TECHNICAL BULLETIN

[Issue No.] GOT-A-0142

[Title] Changing the Rating Plate Size and the Layout of Text on the Rating Plate

[Relevant Models] GS2110-WTBD

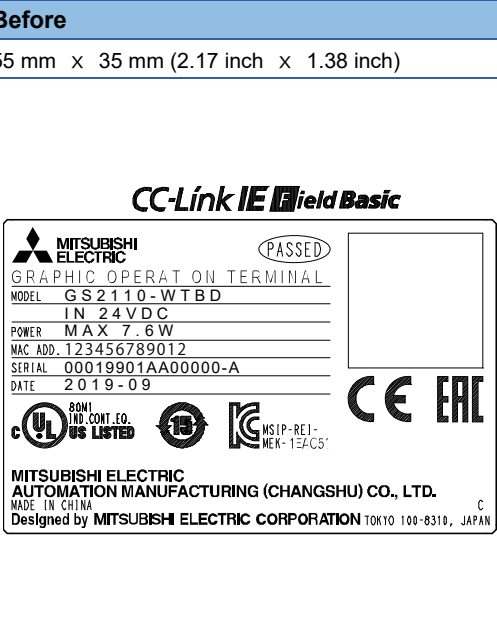
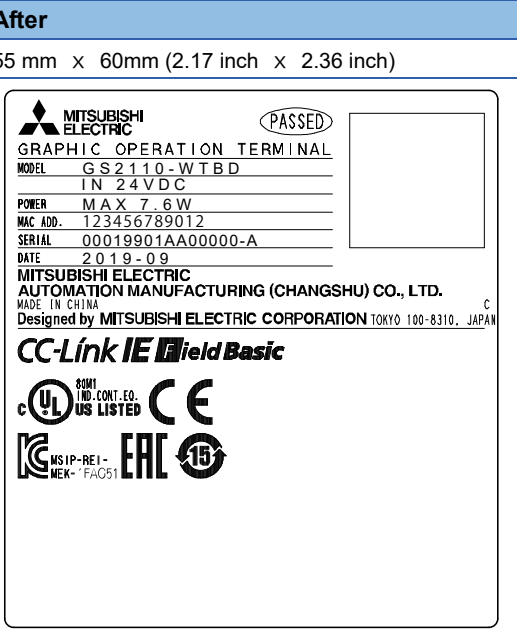
- The size of the rating plate will be changed.
- The layout of text on the rating plate will be changed.

Item	Before	After
Size	55 mm × 35 mm (2.17 inch × 1.38 inch)	55 mm × 60mm (2.17 inch × 2.36 inch)
Layout	 <p>The 'Before' rating plate is smaller (55mm x 35mm) and contains the following text and logos: Mitsubishi Electric logo, 'PASSED' stamp, 'GRAPHIC OPERATION TERMINAL', 'MODEL GS2110-WTBD', 'IN 24VDC', 'POWER MAX 7.6W', 'MAC ADD. 123456789012', 'SERIAL 00019901AA00000-A', 'DATE 2019-09', 'CC-Link IE Field Basic' logo, CE and EAC marks, and manufacturer information: 'MITSUBISHI ELECTRIC AUTOMATION MANUFACTURING (CHANGSHU) CO., LTD. MADE IN CHINA. Designed by MITSUBISHI ELECTRIC CORPORATION TOKYO 100-8310, JAPAN'.</p>	 <p>The 'After' rating plate is larger (55mm x 60mm) and contains the following text and logos: Mitsubishi Electric logo, 'PASSED' stamp, 'GRAPHIC OPERATION TERMINAL', 'MODEL GS2110-WTBD', 'IN 24VDC', 'POWER MAX 7.6W', 'MAC ADD. 123456789012', 'SERIAL 00019901AA00000-A', 'DATE 2019-09', 'CC-Link IE Field Basic' logo, UL, CE, and EAC marks, and manufacturer information: 'MITSUBISHI ELECTRIC AUTOMATION MANUFACTURING (CHANGSHU) CO., LTD. MADE IN CHINA. Designed by MITSUBISHI ELECTRIC CORPORATION TOKYO 100-8310, JAPAN'.</p>
